For: Self-Route Expandable Multi-Memory Packet Switch with Distributed Scheduling Means

Serial Number: 09/683,429

Response and Amendment Under 37 C.F.R. §1.111

FIG. 3

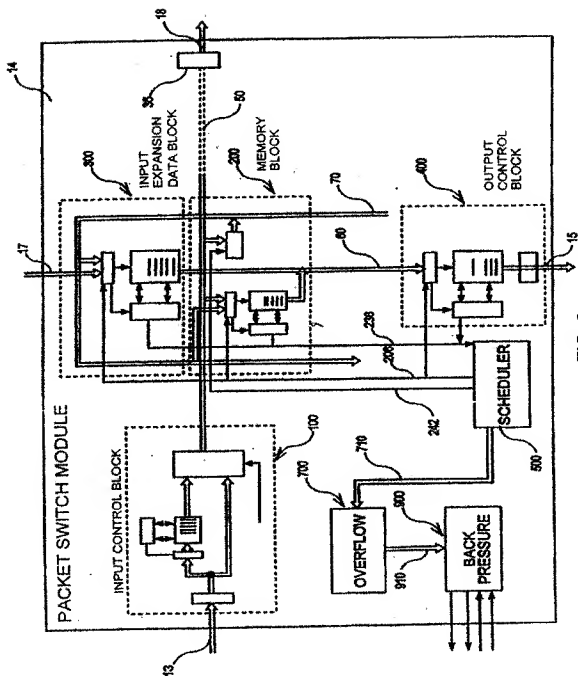
The Office Action stated an objection to Figures 3-8 as failing to comply with 37 CFR 1.121(d) because descriptive labels necessary for understanding the drawings are missing. The Office Action also stated that the quality of the connections shown on Figure 8 is not acceptable. A proposed set of drawings to overcome the objections is attached to this amendment as Appendix A. Each sheet has been labeled "Replacement Sheet" to be in compliance with 37 CFR 1.121(d).

The Office Action stated that Claims 1 – 14 are objected to because “a memory block located at each of the cross points” is unclear because memory location seems to be irrelevant in the claim, contrary to the memory connection/association to the ports as claimed. Applicants have amended Claim 1 to clarify that a memory block is associated with an input port and an output port and is not dependent on physical location. Claim 1 now reads, “...wherein the packet switch comprises a plurality of memory blocks, each memory block associated with one of said cross points ...”.

each memory block associated with one of said cross points ...”. Support for Applicants’ claim 1, as amended, can be found, for example, in paragraph 0025 and Figure 3.
